UNITED STATES OF AMERICA
NUCLEAR REGULATORY COMMISSION

In the Matter of)
PUBLIC SERVICE COMPANY OF)
NEW HAMPSHIRE, et al.)
(Seabrook Station, Units 1 and 2))

NRC STAFF RESPONSE TO FIRST SET OF
INTERROGATORIES AND REQUEST FOR PRODUCTION
OF DOCUMENTS OF THE STATE OF NEW HAMPSHIRE

FIGURE 2.4.29

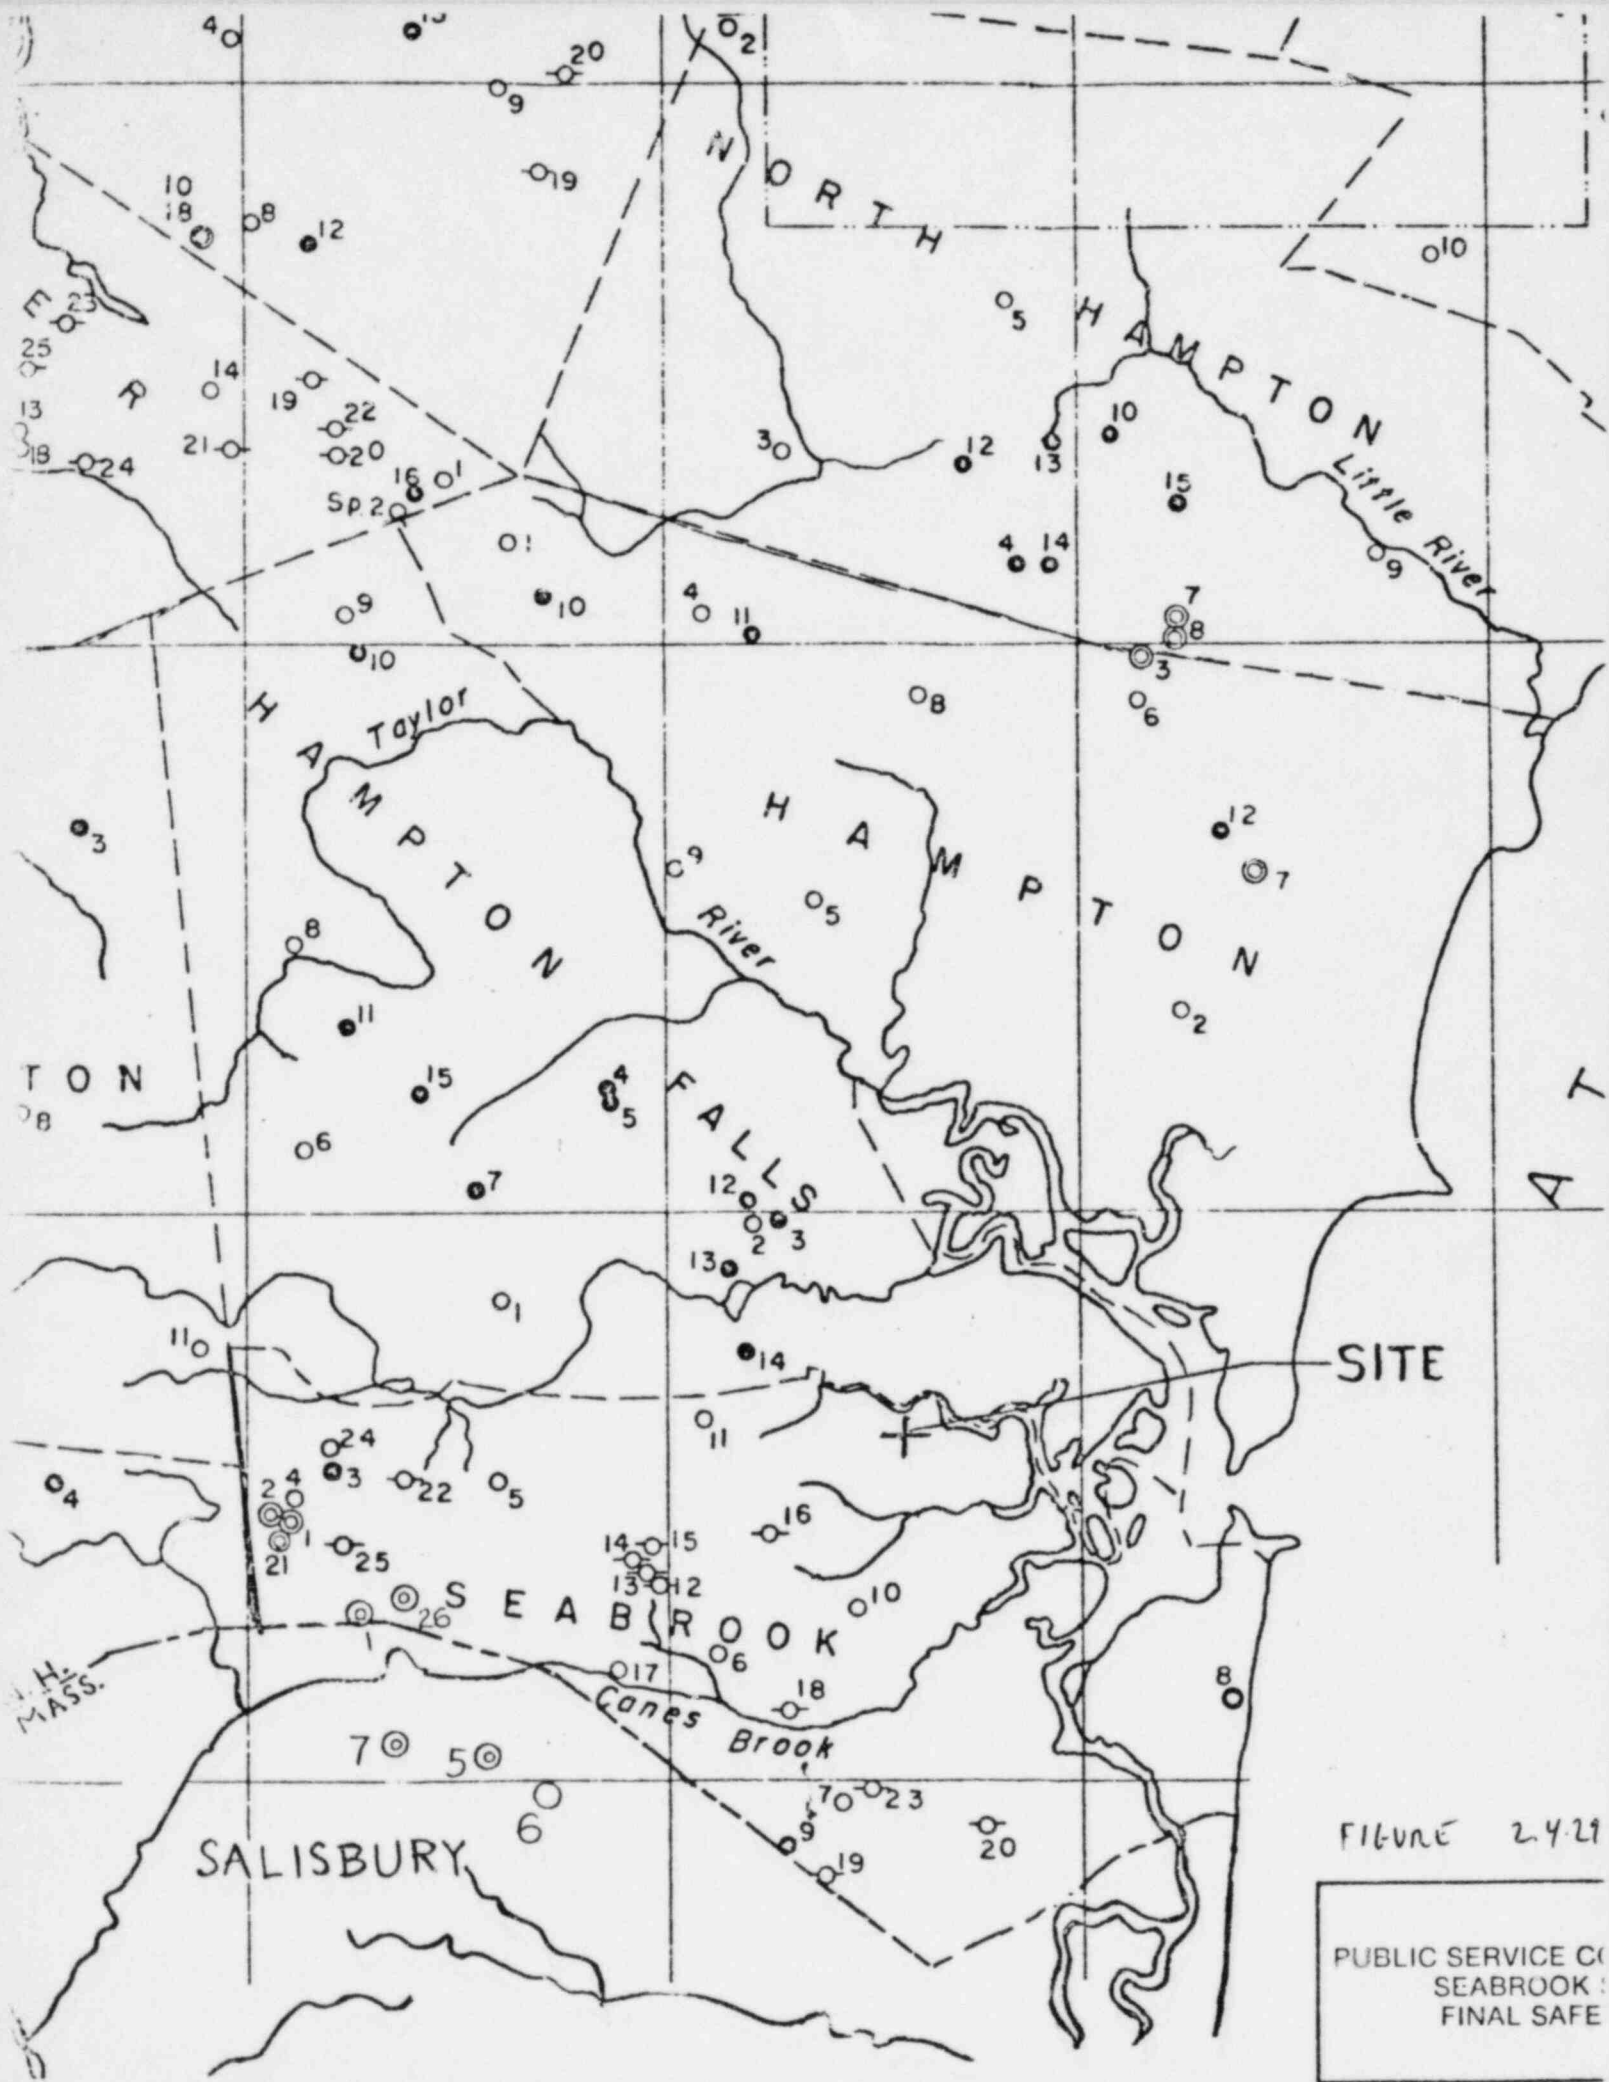
Identify the location and distance from the plant site of the five (5) nearest wells used for domestic water supplies.

Enclosed is figure 2.4.29 from the Applicant's FSAR which shows wells near the site. It should be noted, however, that this question has no bearing on the groundwater contamination problem, because as is clearly stated in Section 5.9 of the Environmental Statement, all groundwater flow would be toward the marsh and estuary and away from any wells. Therefore, in the Staff's view it is not related to the Contention SAPL Supp. 3.
